ADDENDUM NO. 1

PROJECT NAME: Wick Alumni Center Life Safety & HVAC Improvements
UNL PROJECT NUMBER: C120P021
BID INVITATION NUMBER: 2222-13-7200

CONSULTANT: Farris Engineering
ADDRESS: 818 P Street, Suite 100

DATE OF ISSUANCE: September 3, 2013
DATE OF BID OPENING: September 18, 2013

SCALE: 1/4" INCH = 1 FOOT
12" 0 5'

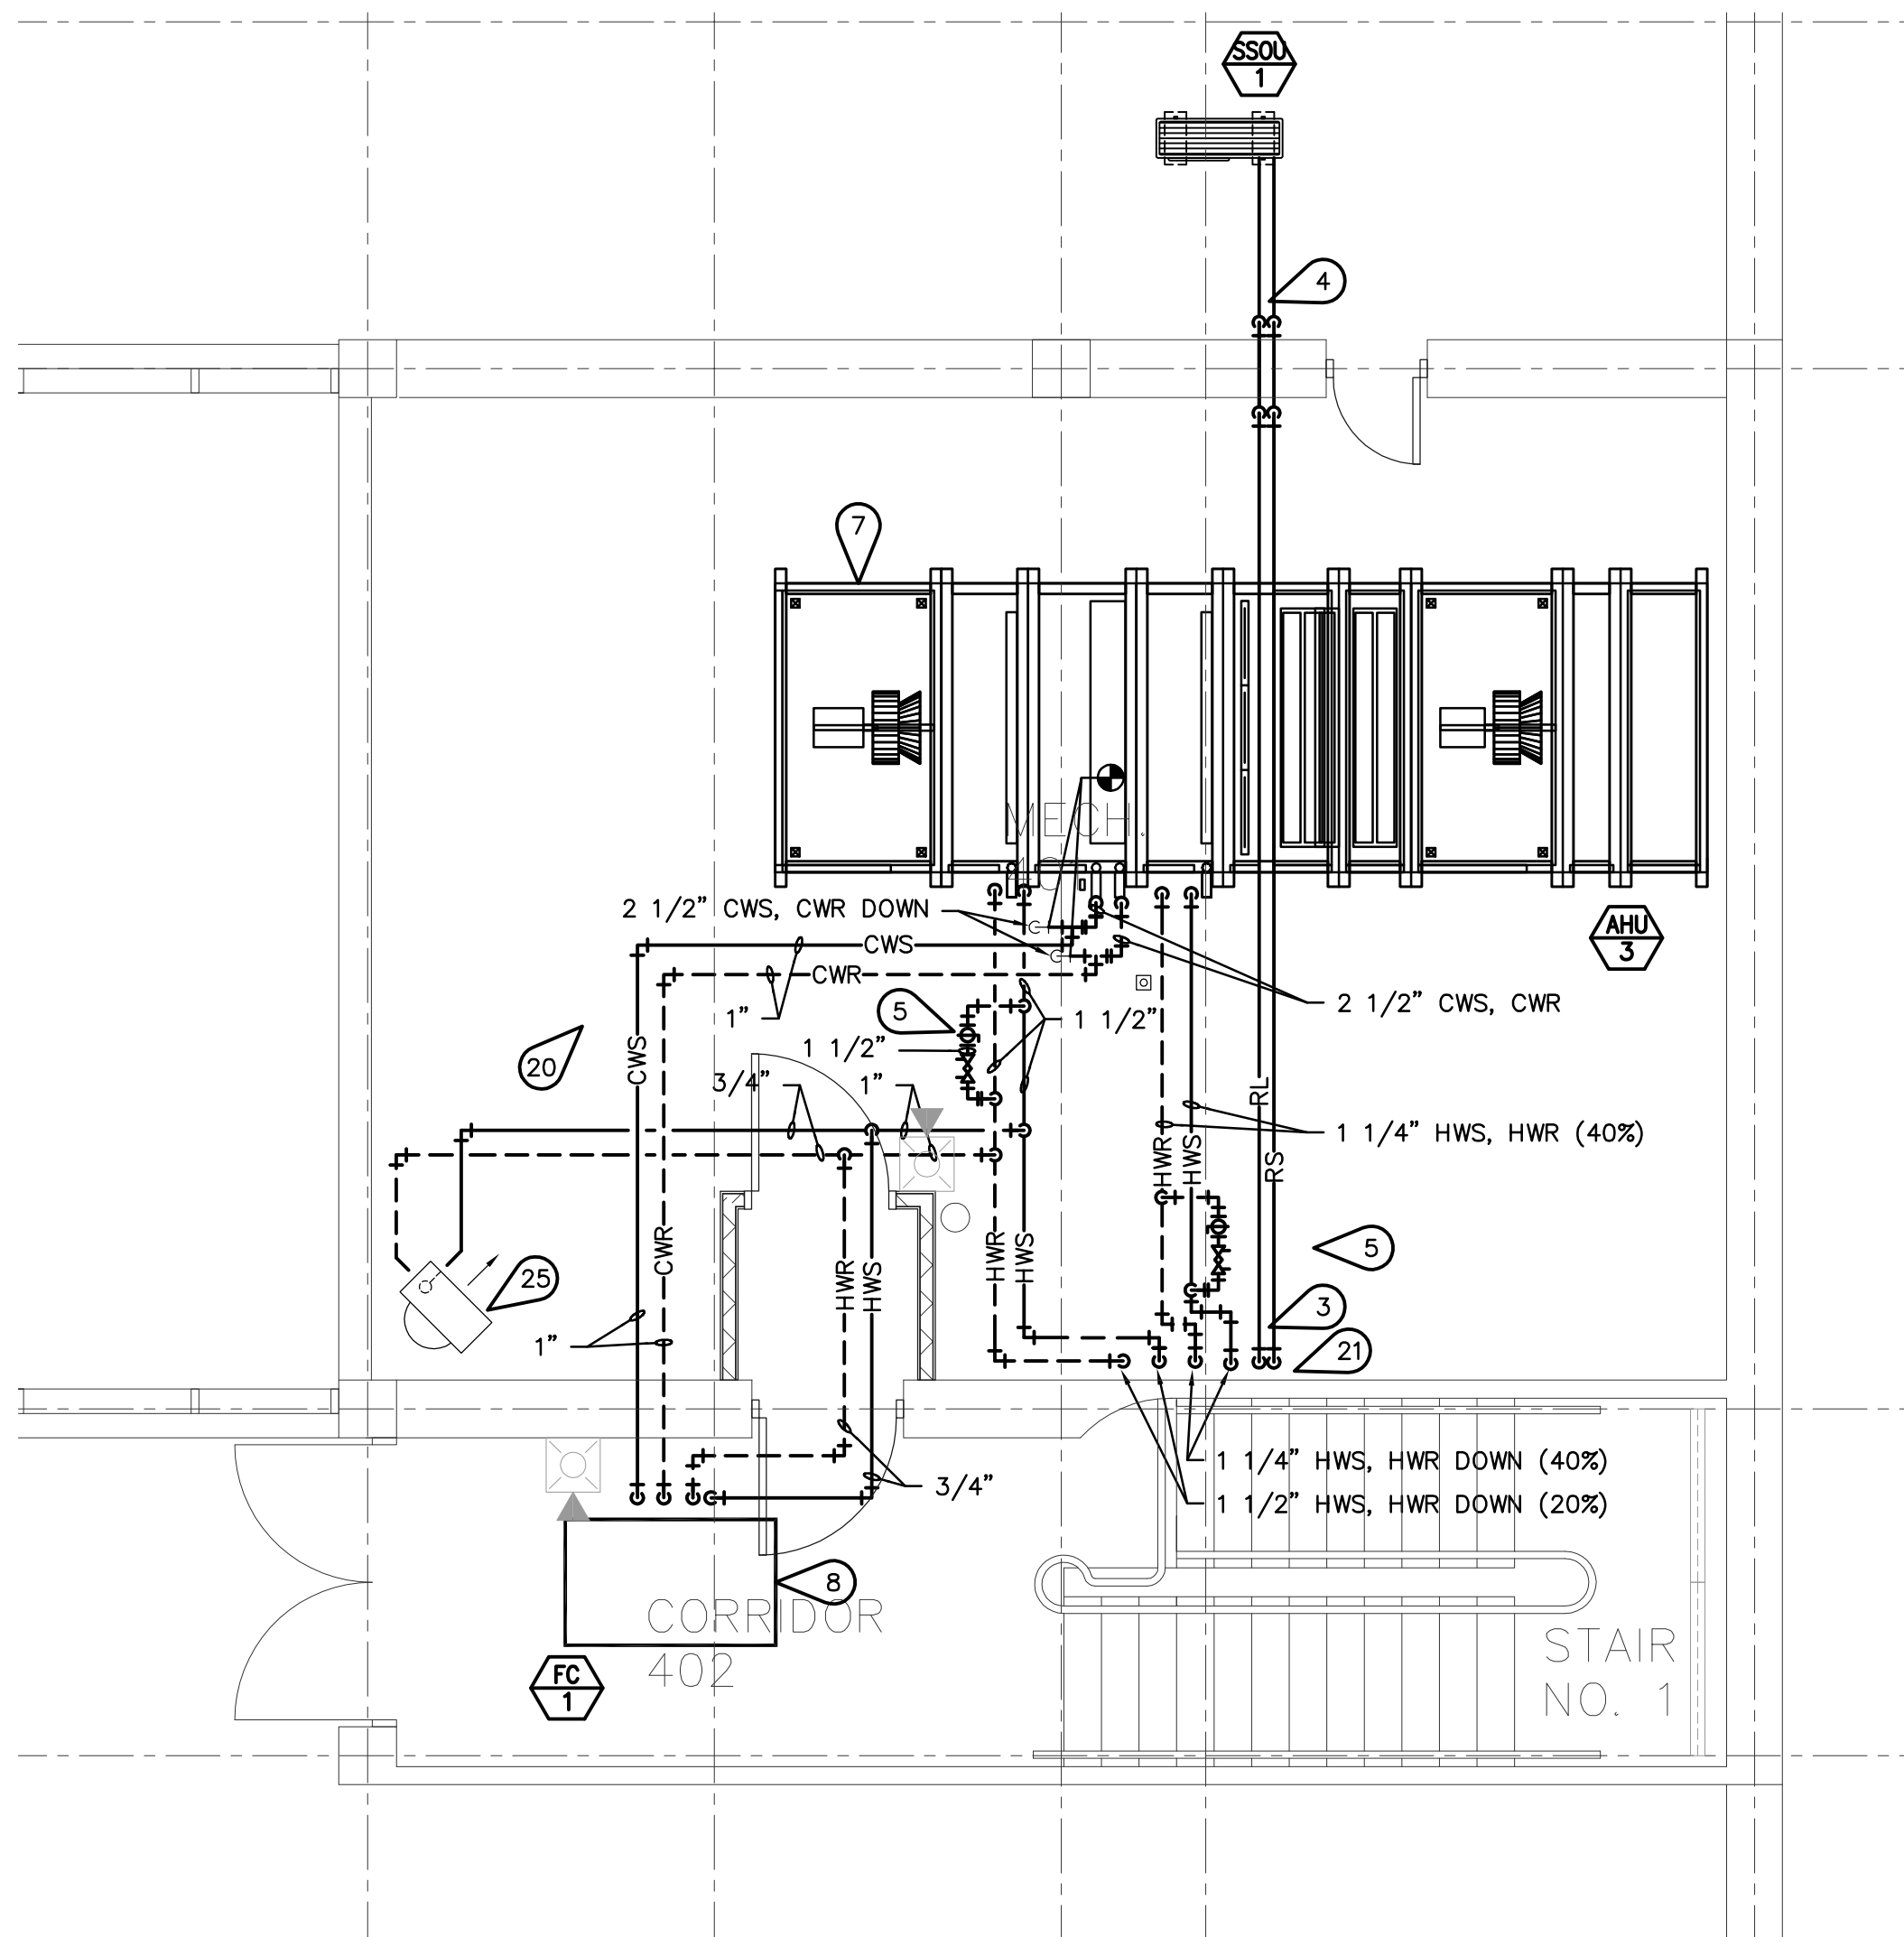
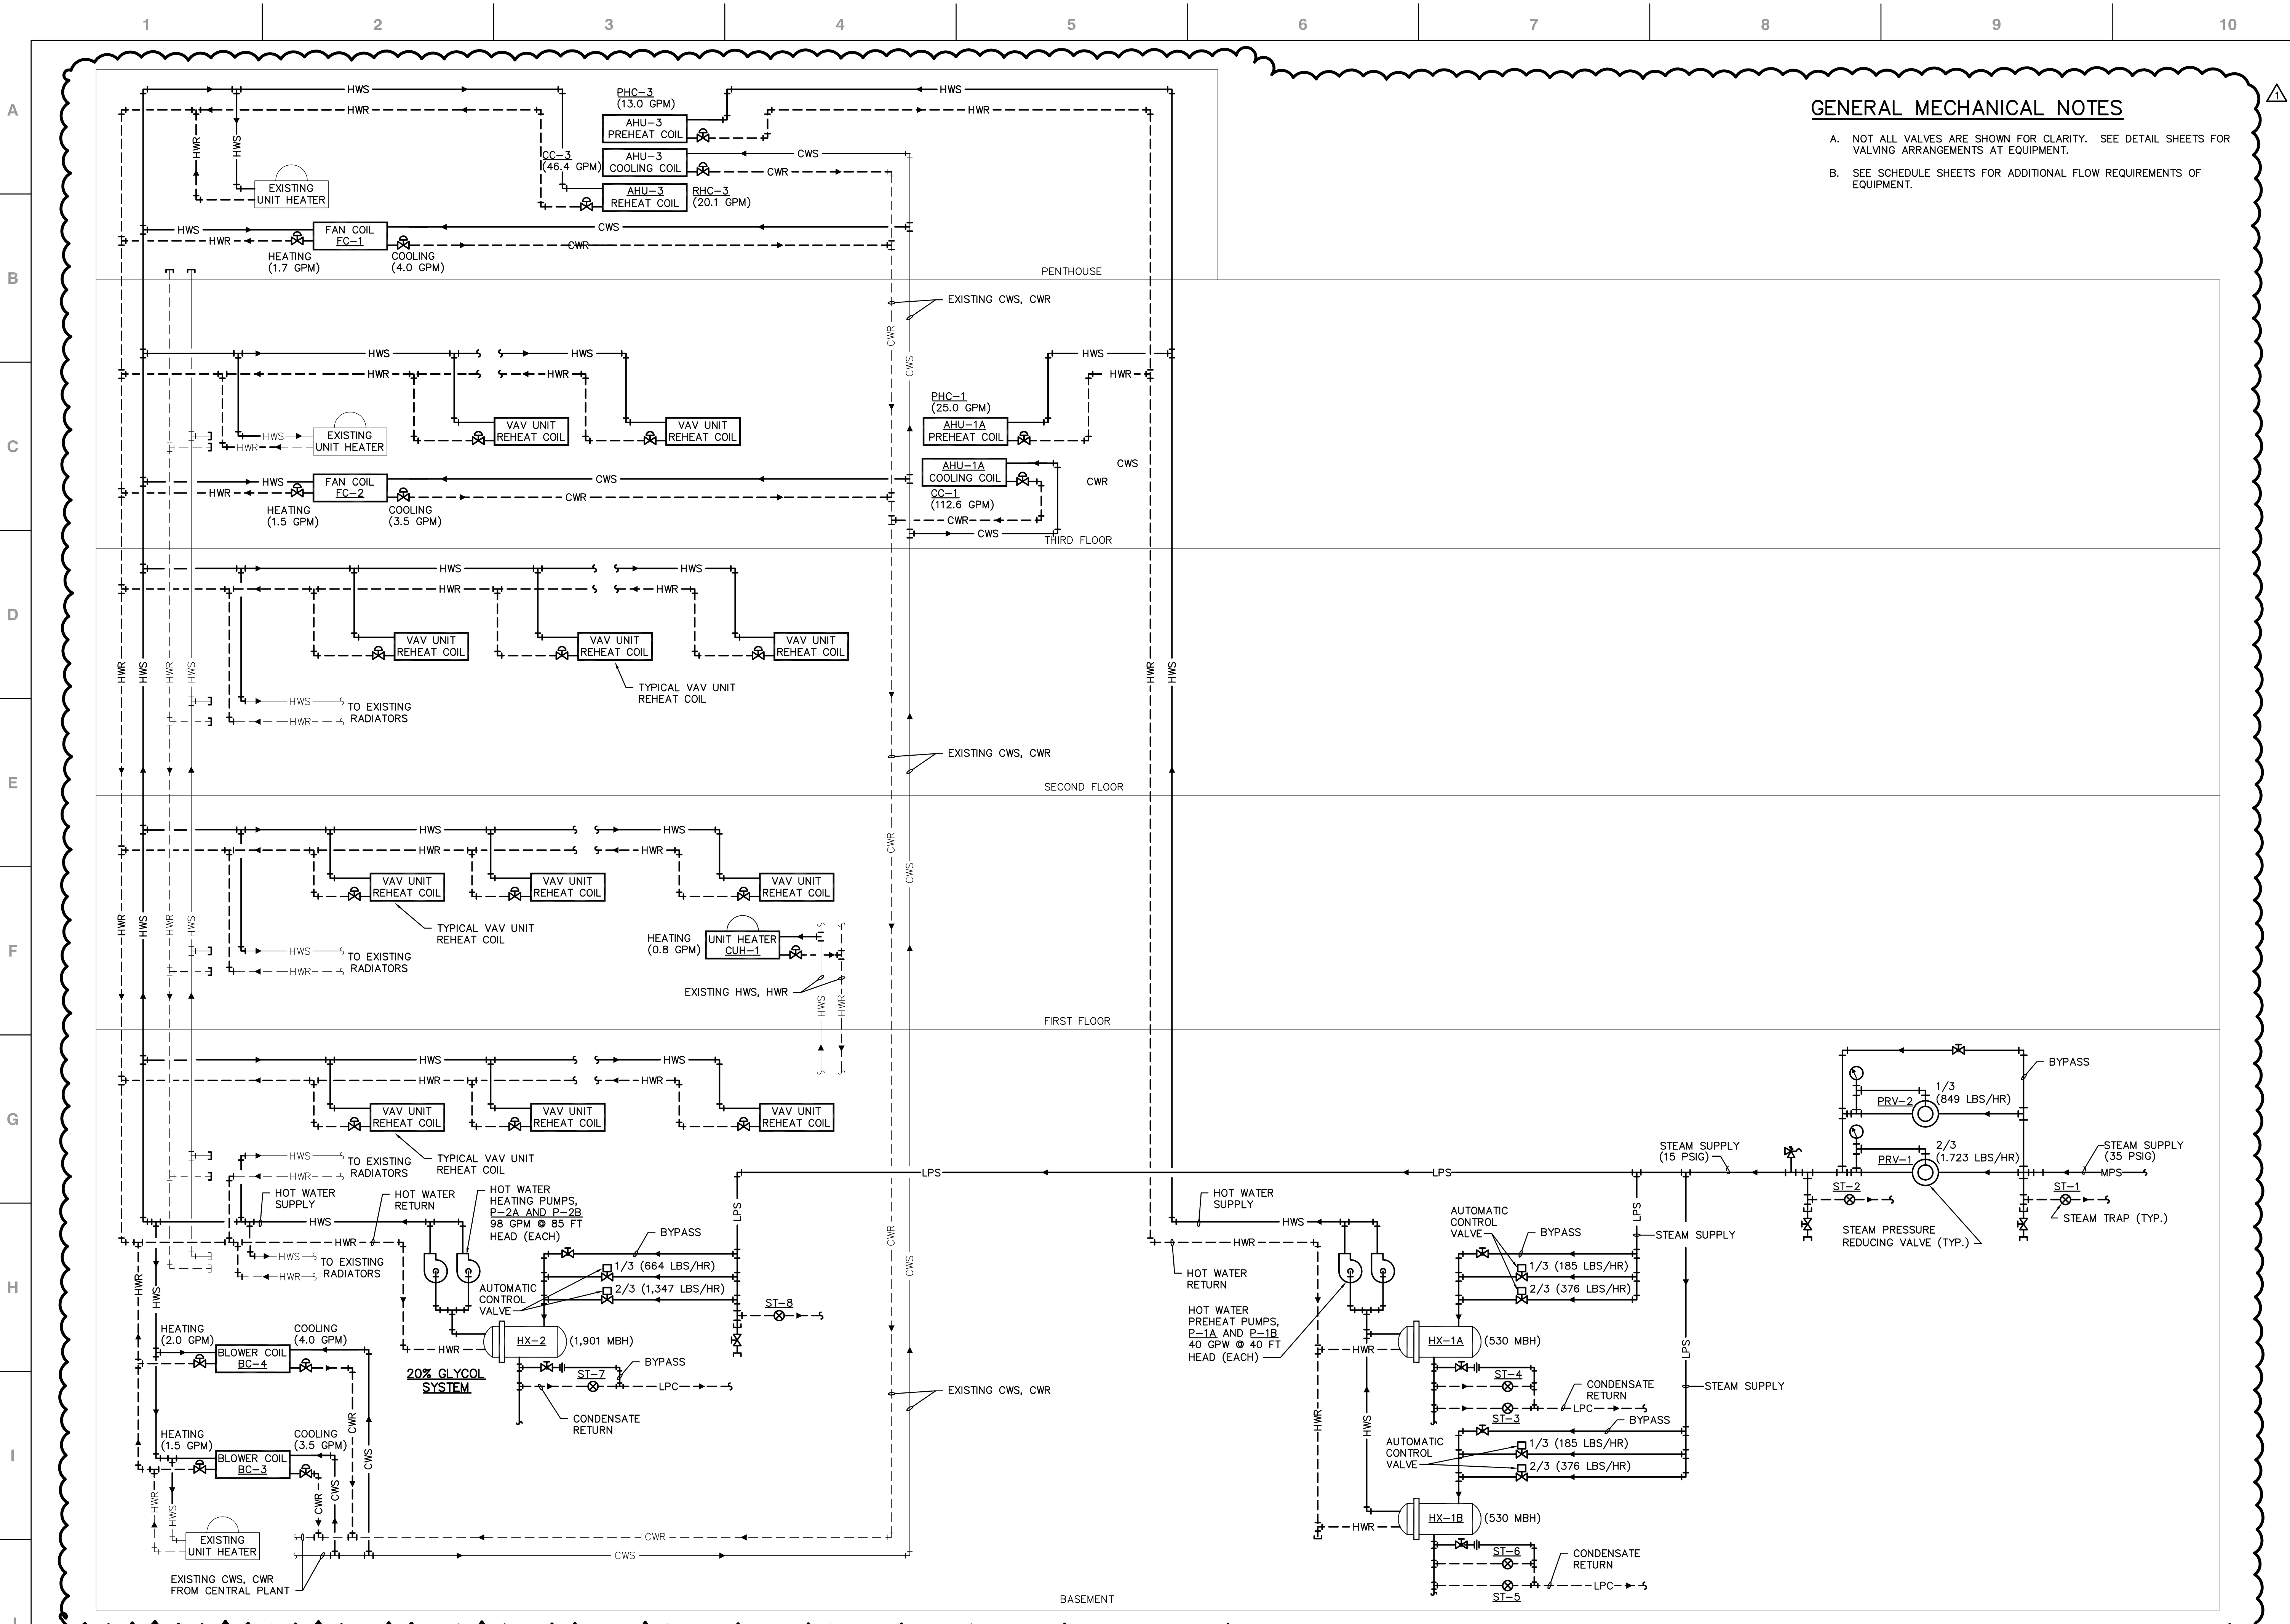
7. SHEET A1-3, MECHANICAL 401 RENOVATION PLAN: At the north wall of Mechanical Room 401, add the following note: “See Sheet M2-3 ‘Mechanical 401 HVAC Piping Plan’ for exterior pipe penetration requiring sealant”.

12. SHEET M2-3, LARGE-SCALE HVAC PIPING AND PLUMBING PLANS:
 - A. This sheet has been reissued in its entirety as a part of Addendum No.1.
 - B. "MECHANICAL ROOMS 027, 028 HVAC PIPING AND PLUMBING PLAN" has been revised.

- C. Mechanical Keynote #27 has been revised.
13. SHEET MD2-3, LARGE-SCALE HVAC PIPING AND PLUMBING DEMOLITION PLANS:
 - A. This sheet has been reissued in its entirety as a part of Addendum No.1.

HYDRONIC SYSTEM DIAGRAM 1
 NO SCALE

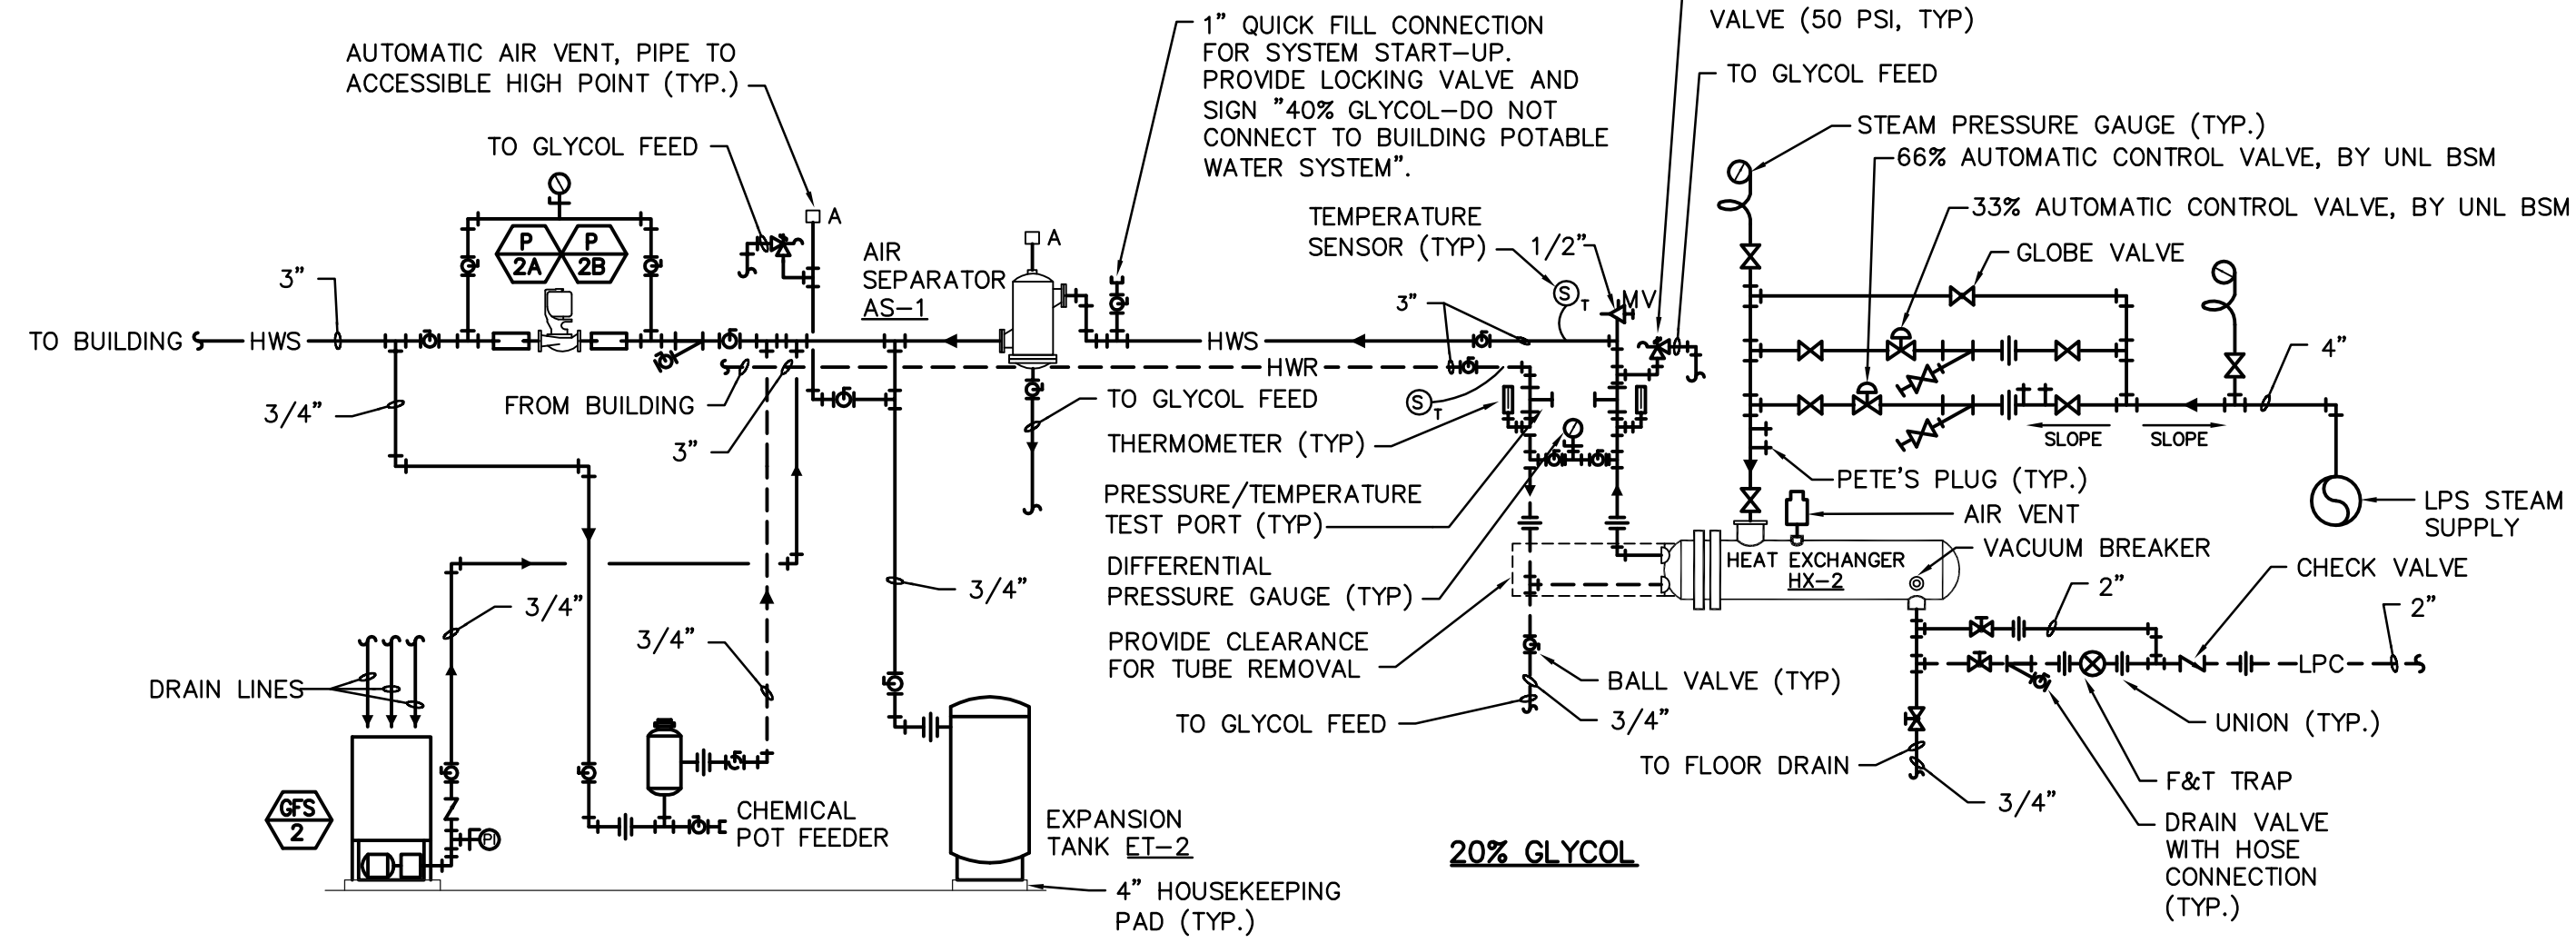
14. SHEET M5-1, MECHANICAL SCHEMATICS:
 - A. This sheet has been reissued in its entirety as a part of Addendum No.1.
 - B. "HOT WATER SYSTEM DIAGRAM" has been renamed to "HYDRONIC SYSTEM DIAGRAM", and has been revised.
